# TECH BULLETIN 125

## Product changes to crankcase, bearing covers, and shaft protector for all 35 and 38 Frame plunger pumps

### New Crankcase Style

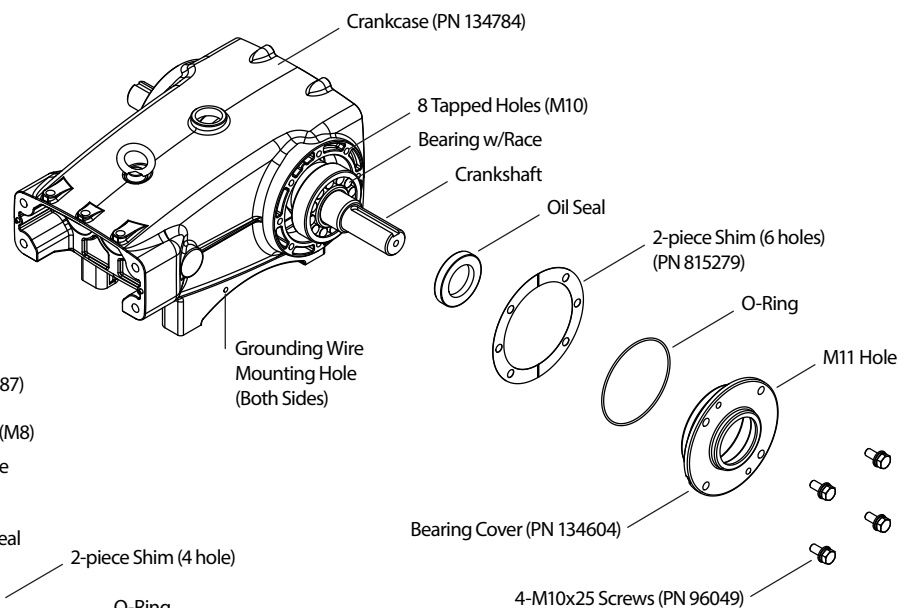
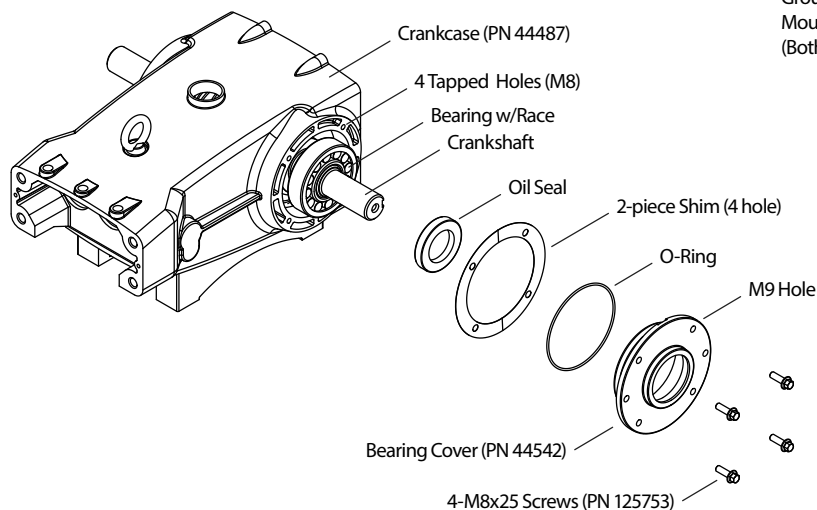
Changes have been made to the crankcase and mounting hardware to better support the weight of direct drive bell housings. This affects all 35 and 38 frame plunger pumps with date codes/serial numbers after June 2018.

- Crankcase bell housing mounting bolt holes number increased from four (4) to eight (8) to better distribute weight of motor on crankcase.
- Bell housing mounting bolt quantity and sizes changed from four (4) M8 to eight (8) M10 bolts.
- M8-sized grounding wire mounting holes (6.75mm x 12mm depth) have been added on both sides of the crankcase.

- Rotated threaded M10 jacking screw hole locations to coincide with the incorporation of additional mounting holes.
- Bearing cover bolt holes enlarged (Four [4] x M11) to accommodate M10 bolt size.
- Shaft protector bolt holes enlarged (Two [2] x M11) to accommodate M10 bolt size.
